SERVICE BULLETIN

NUMBER 181

SUBJECT: Replacement of 1/8 - 7 x 19 Flexible Stainless Steel Control Cables

PA-18A

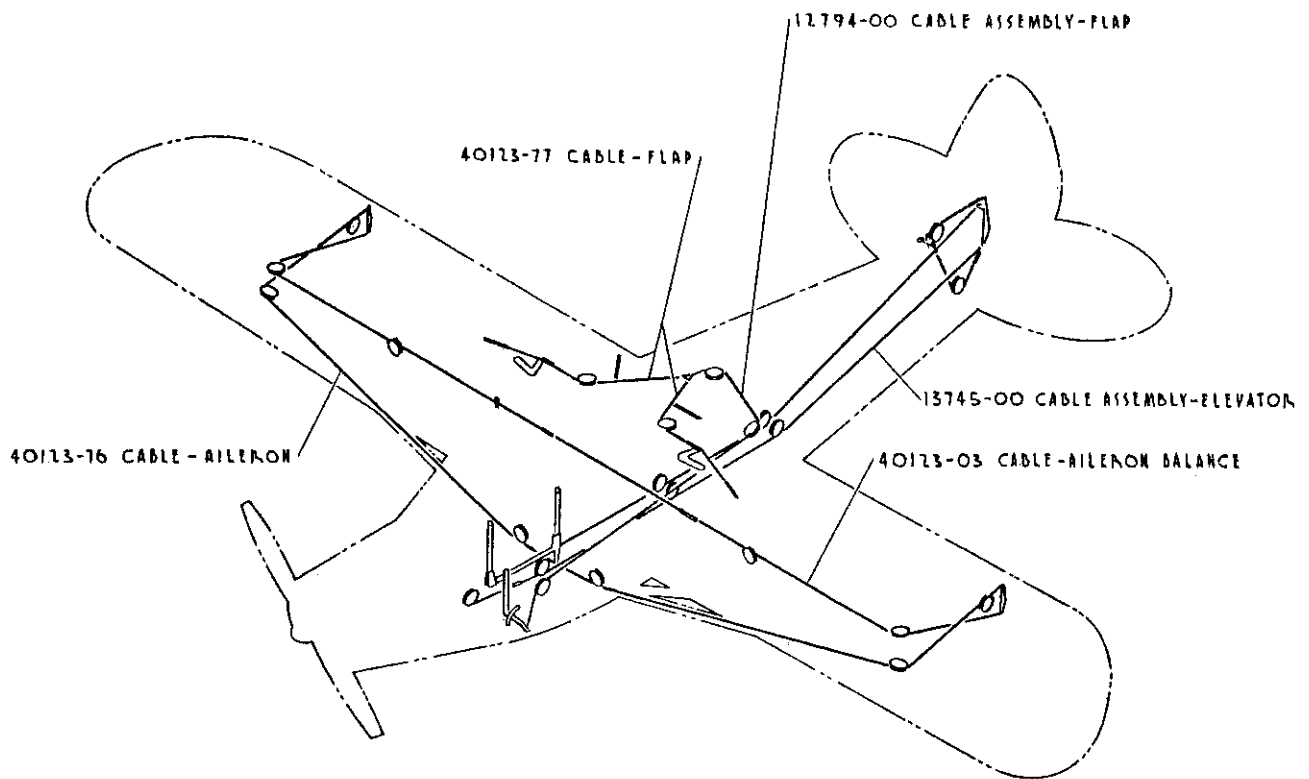
The following is a list of the affected control cables and their respective replacement parts which apply to the aircraft serial numbers listed after "MODELS AFFECTED", exclusive of the aircraft listed under Note "A". See sketches A, B and C for identification.

Replace Stainless Steel Cables			Install Replacement Cables		Aircraft Application	
Part No.	Qty. Req.	Nomenclature	Part No.	PA-18	PA-18A	
12794-03	1	Cable - Flap	12794-00	X		
13271-02	1	Cable - Flap	13271-00			X
13745-02	1	Cable - Elevator, lower	13745-00	X		X
40123-44	2	Cable - Aileron	40123-03	X		X
40123-86	2	Cable - Flap	40123-77	X		
40123-87	2	Cable - Aileron	40123-76	X		X
